VIRGINIA ELECTRIC AND POWER COMPANY
RICHMOND, VIRGINIA 23261

VIRGINIA ELECTRIC AND POWER COMPANY
NORTH ANNA POWER STATION UNITS 1 AND 2
INSERVICE TESTING PROGRAM FOR PUMP AND VALVES
THIRD TEN YEAR INTERVAL UPDATE
REQUEST FOR ADDITIONAL INFORMATION

**North Anna Unit 1
Inservice Testing Program
Revised Relief Requests**

**North Anna Unit 2
Inservice Testing Program
Revised Relief Requests**

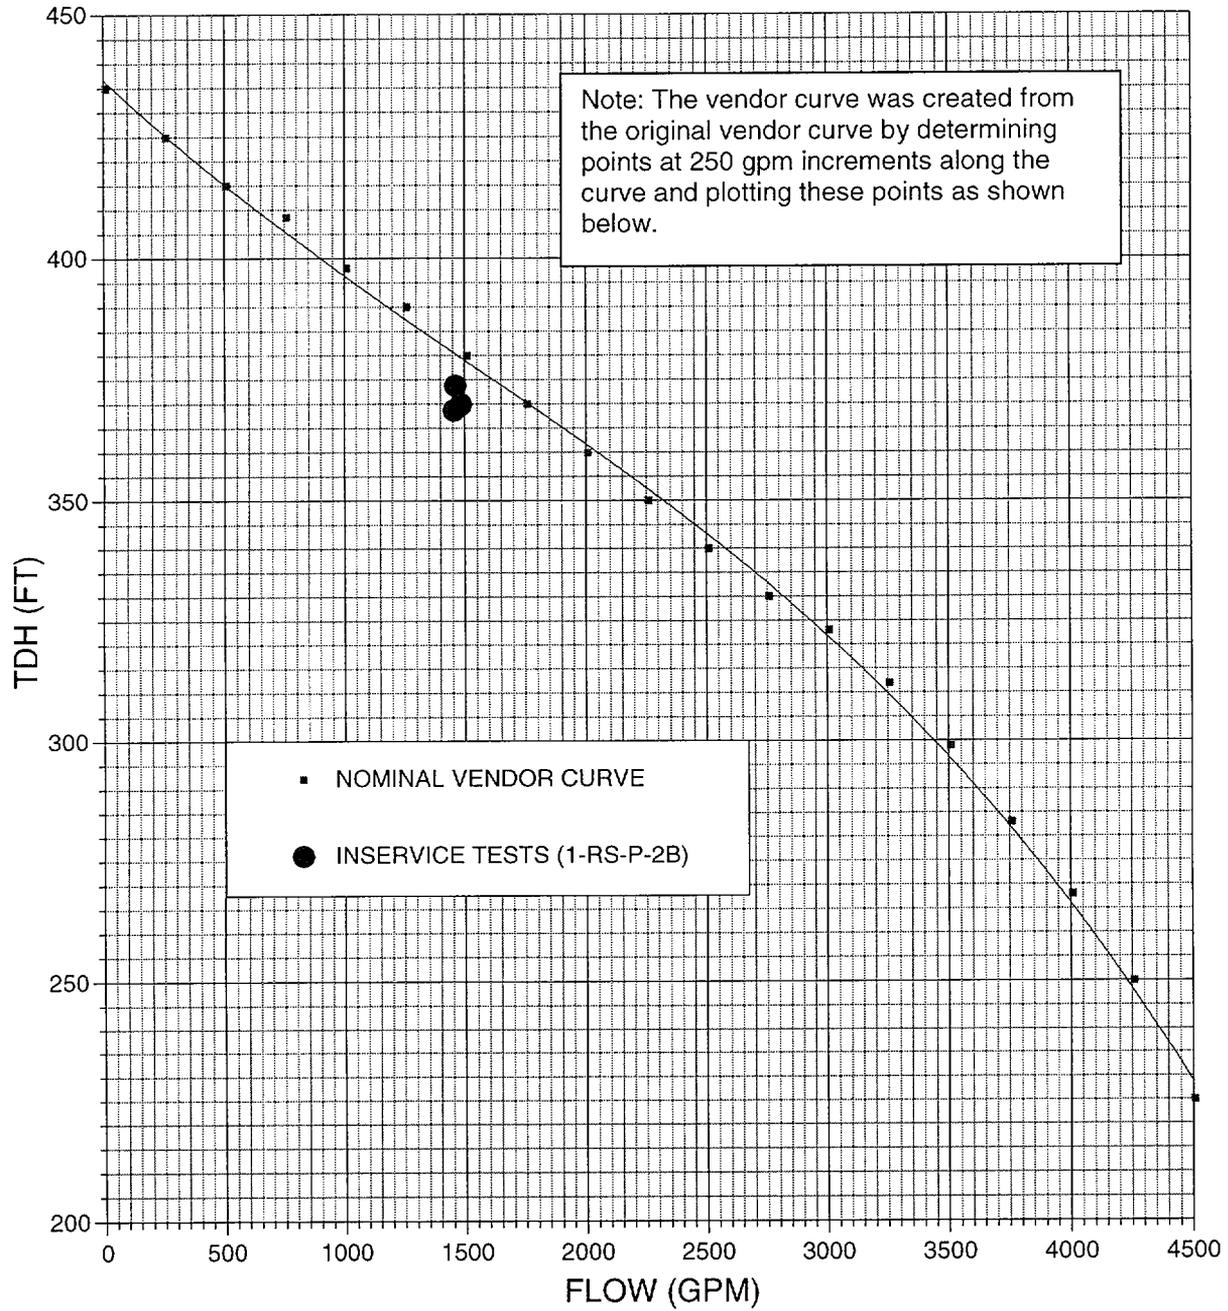
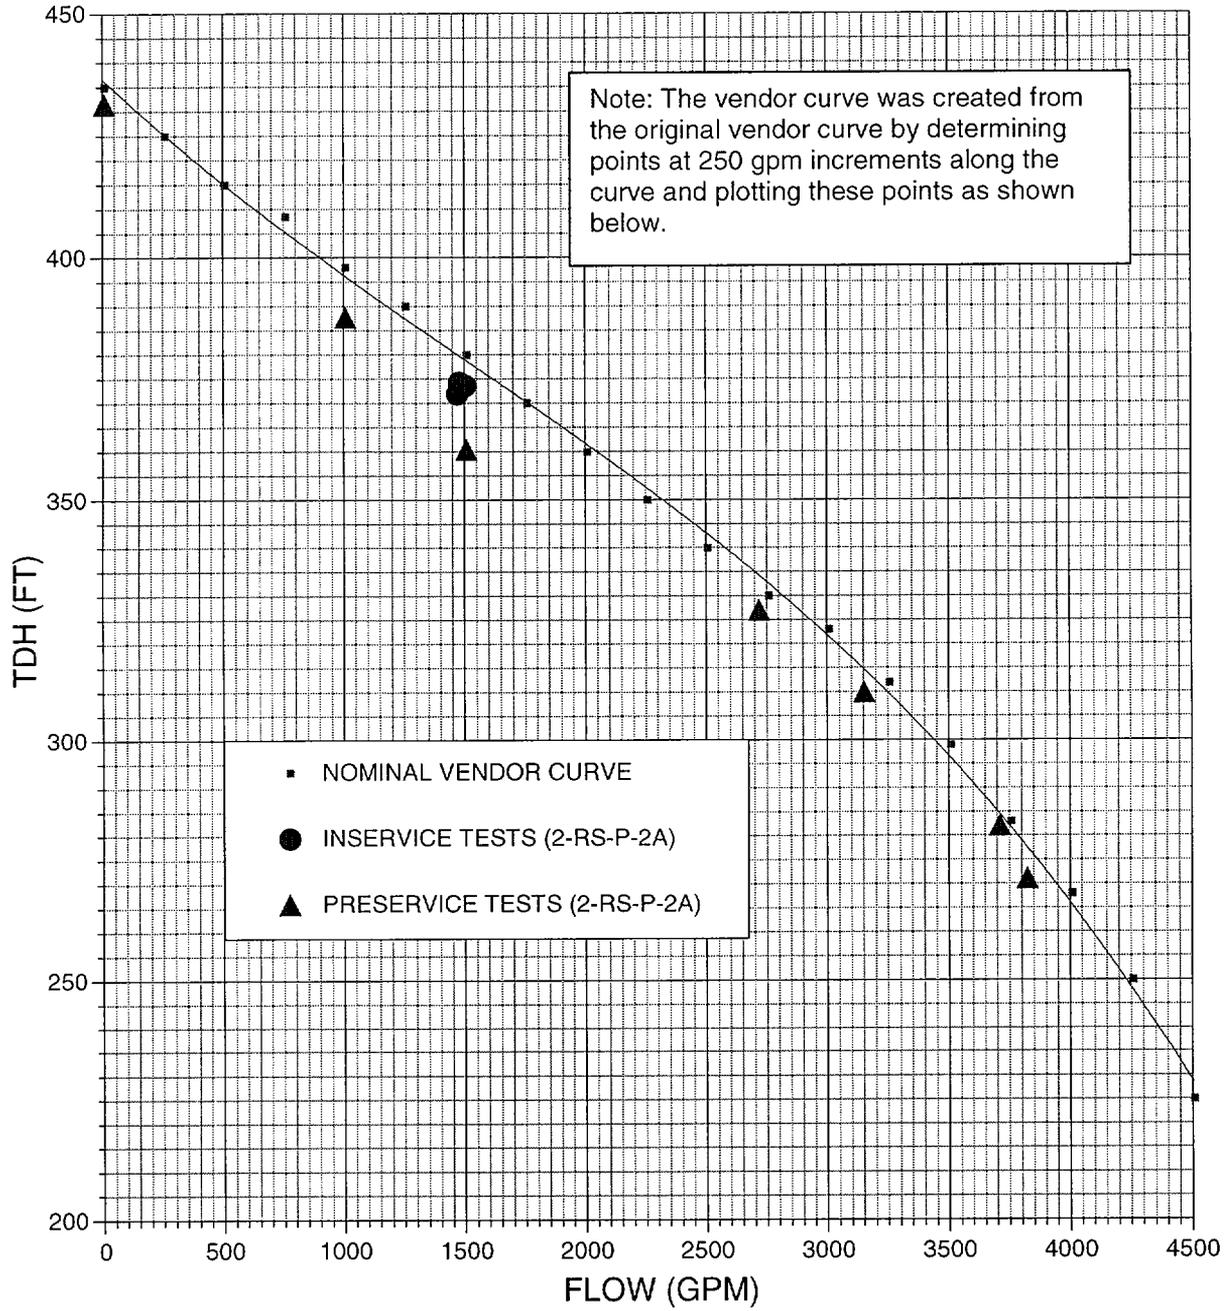
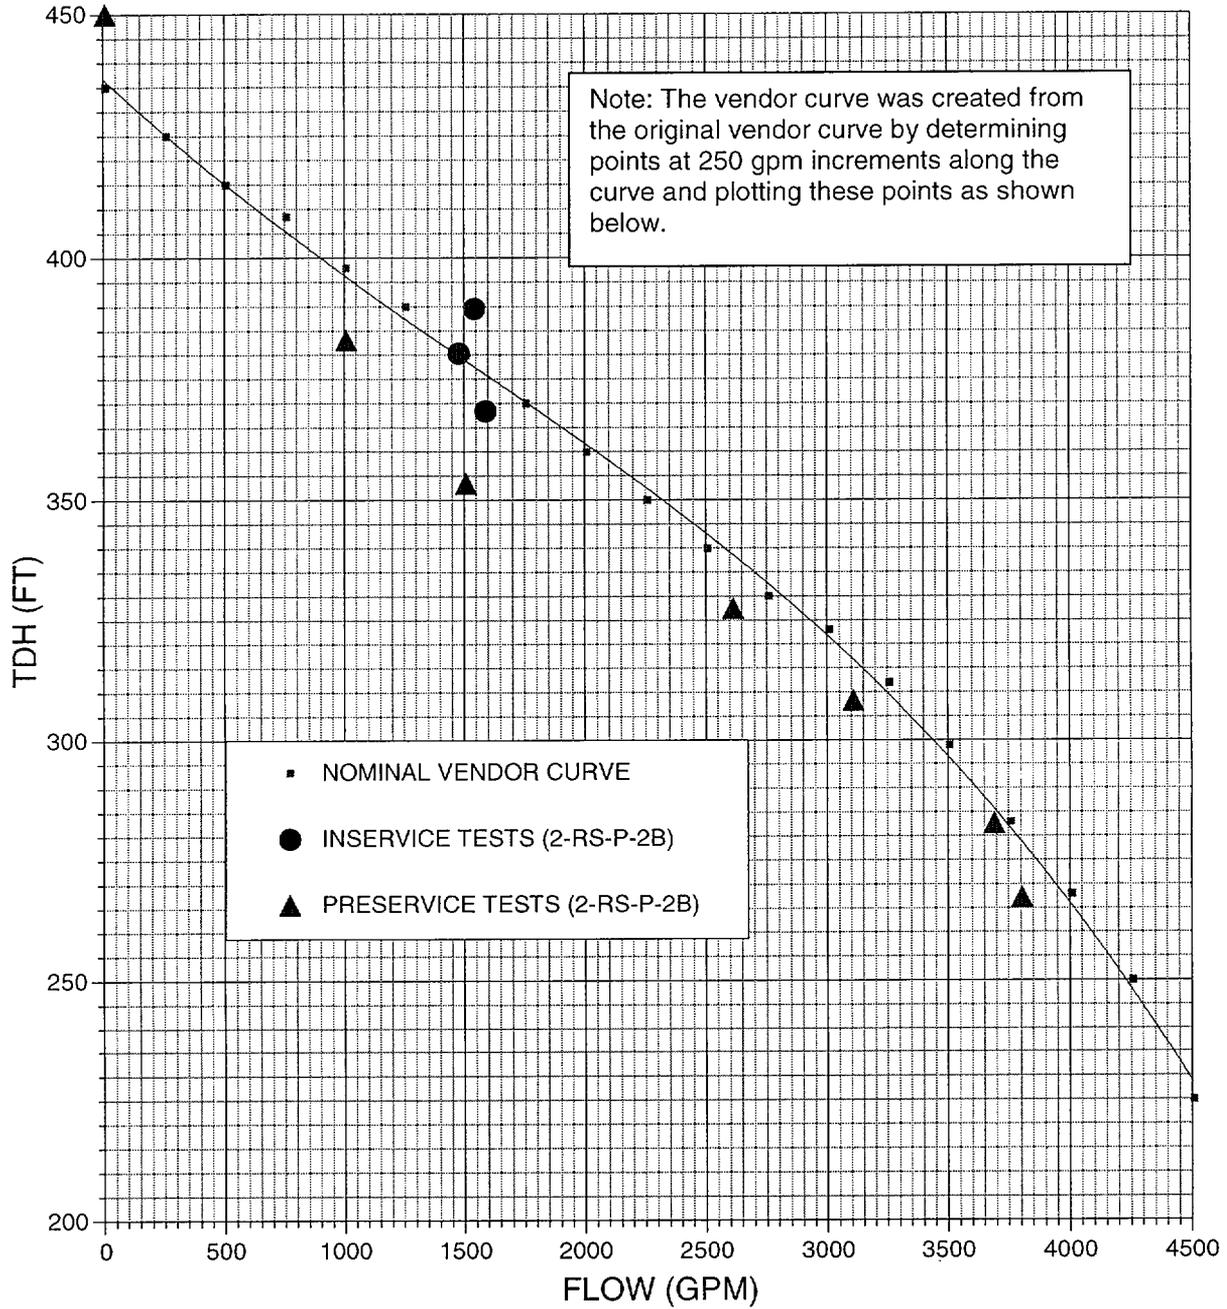
RELIEF REQUEST NO.	DESCRIPTION OF CHANGE
	Unit 2 pumps. There were no preservice tests performed for the Unit 1 pumps.
P-7	For auxiliary service water pump 2-SW-P-4, the need for and consequently the request for relief from the discharge pressure instrument accuracy requirement was eliminated. Based on guidance from ASME OM Interpretation 95-6, certain terms in the instrument loop accuracy calculation can be excluded, resulting in a calculated value for loop accuracy that is within $\pm 2\%$. In the alternate testing section, 10 CFR 50.55a(a)(3)(i) was added as a reference.

FIGURE P-6.1

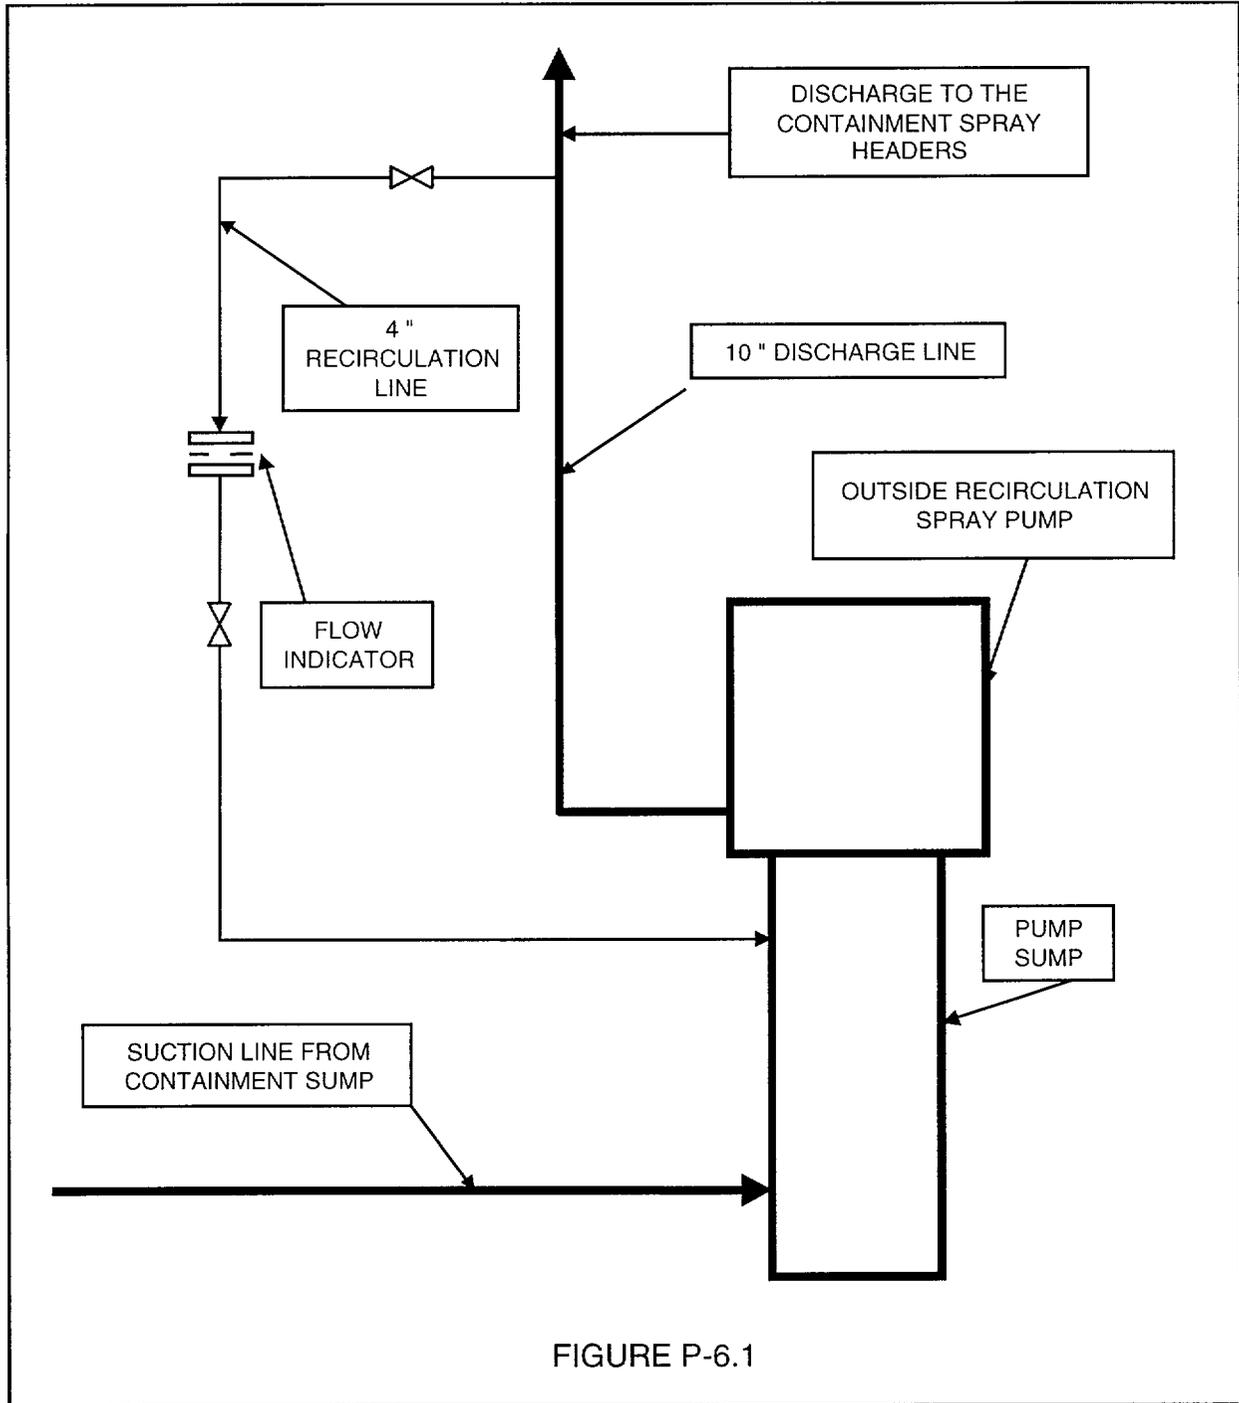
The test loop for the outside recirculation pumps consists of a 10" pump discharge line feeding into a 4" recirculation line which feeds back to the pump sump. Refer to Figure P-6.1. With this test loop, pump design flow cannot be established. Also, the discharge piping was not designed to be temporarily reconfigured so that pump design flow could be achieved.

As an alternative to flow testing at the design flow rate, the test loop shown in Figure P-6.1 will be used. Reference flows are typically established with this test loop in the range of 1450 to 1500 gpm, whereas the pump design flow is 3640 gpm. The low reference flows result from restrictions due to the small 4" recirculation line and the limited volume of water in the test loop. The limited water volume results in a rapid temperature rise in the test loop due to heat loads added by the running pump. This temperature rise affects repeatability of the measured hydraulic parameters. Therefore, care must be taken to ensure that the pump run time is limited and that the flow rate is maintained within an optimal range.

FIGURE P-6.2

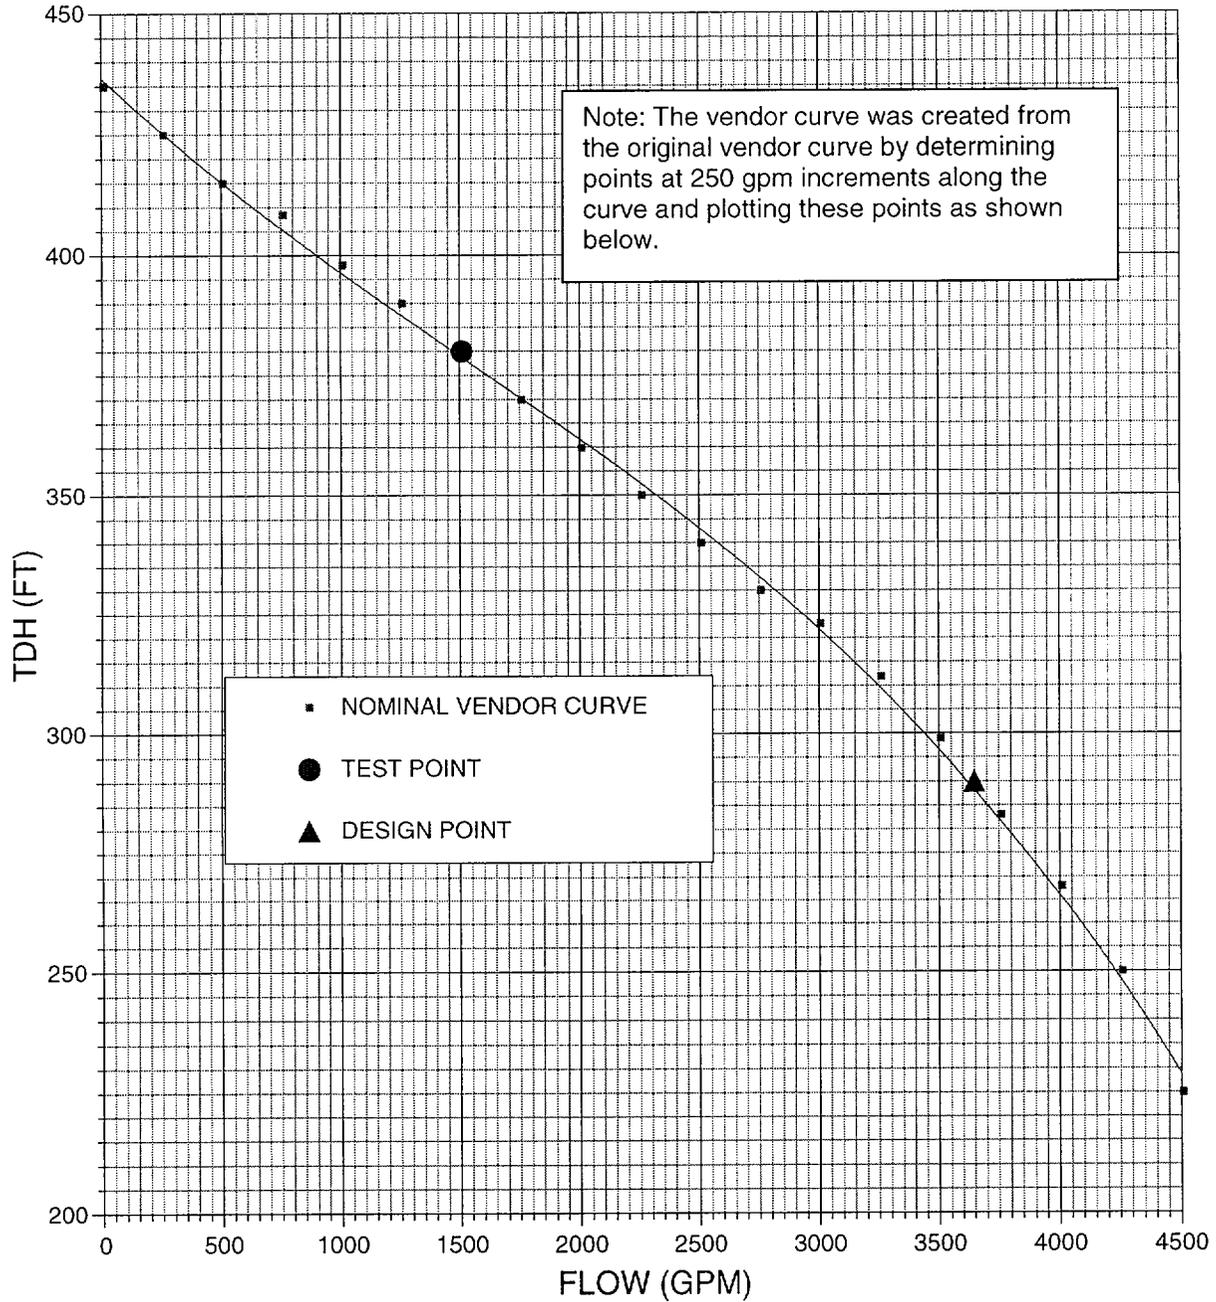
In the 1450 to 1500 gpm range of the head curve for these pumps, the head curve is not flat, but well sloped. Refer to Figure P-6.2. Therefore, as performance degrades due to internal recirculation caused by increasing internal pump clearances, the differential pressure will measurably decrease for a given reference flow rate. As discussed above, testing the outside recirculation spray pumps over the full range of the pump curve and measuring at least five points along the curve is impractical.

As an alternative to testing within 20% of the design flow, the reference values will be established at approximately 40% of the design flow. It is our understanding that testing at design flow is important for pumps with characteristic head-flow curves that are flat or gently sloping in the low flow region (little change in developed head with increasing flow). In the low flow region, increasing internal flows, usually due to wear, are difficult if not impossible to detect. Pumps with the "flat" curves at low flows should be tested at near design conditions to determine if increasing internal recirculation flows have degraded pump performance to the point where design requirements cannot be met. This situation does not apply to the outside recirculation pumps if they are tested at 40% of design flow. Testing at the reference flows will detect pump degradation because the pump curve is well sloped at the point of testing. Refer to Figure P-6.2.
